Spur
Work Order ID 153242-1

Item Name: Cutter Sub Assembly

ENGINEERING CHANGE NOTICE NO.

DWG TITLE: CUTTER SUB ASSY

SHEET 1, ZONE A6 IS:

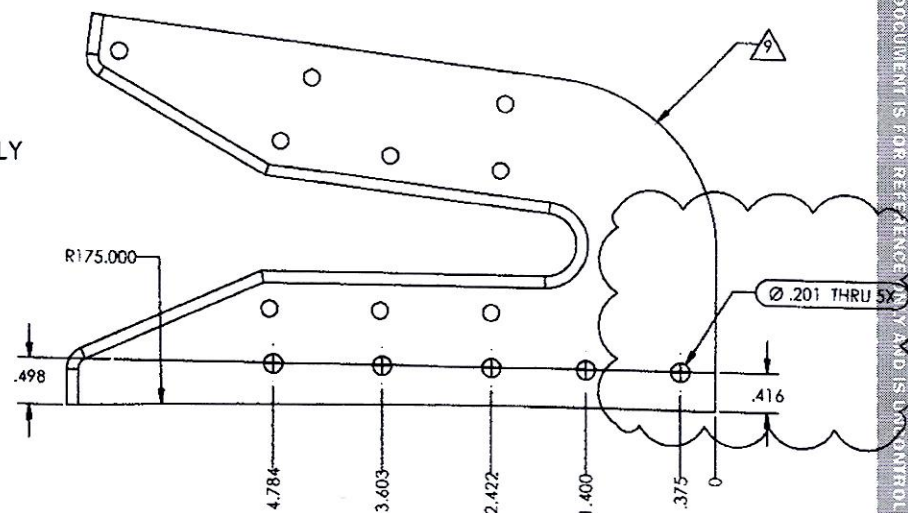
REASON: REVISED NOTES

- 1 MATERIAL: ALUMINUM 7075-T651 PER AMS-QQ-A-250/12
- 2 FINISH IAW MPP-172 SECTION 2.1, 3.3 & 4.3.
- 3 MATERIAL: A157-2 TOOL STEEL
CONDITION: ANNEALED
POST PROCESS: HEAT TREAT TO 58-62 Rc ROCKWELL HARDNESS
- 4 FINISH: PRIME IAW MPP-172 SECTION 3.3; 1-2 MIL MAX
- 5 DEBURR AND BREAK ALL SHARP EDGES EXCEPT WHERE OTHERWISE NOTED
- 6 IDENTIFY IAW MPP-120
- 7 APPLY F/N 5 AS REQUIRED TO ALL FAYING SURFACES OF F/N 2 UPON ASSEMBLY
- 8 CUTTING EDGE INTENDED TO BE SHARP, DO NOT BREAK SHARP EDGE
- 9 ALL DIMENSIONS NOT SPECIFIED ARE CONTROLLED BY 646.9710.

SHEET 7, ZONE C3 IS:

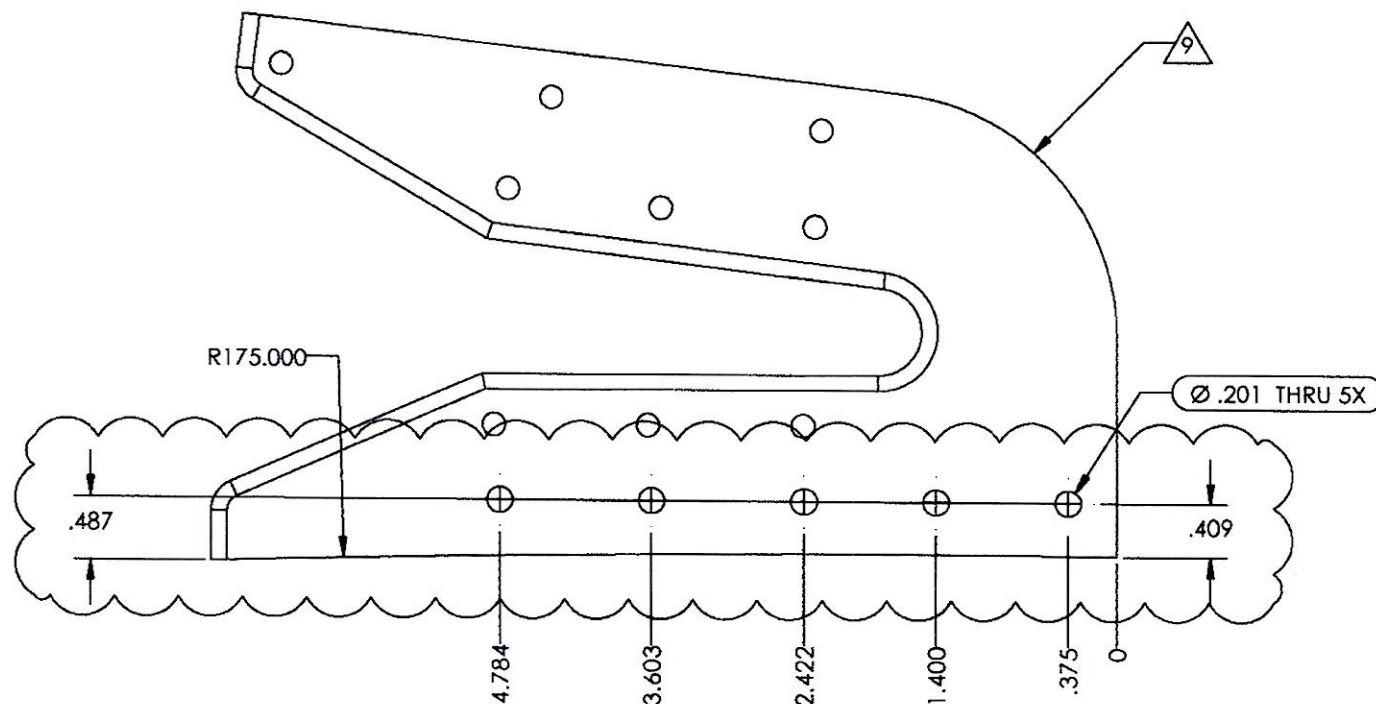
REASON: REVISED DIMENSIONS
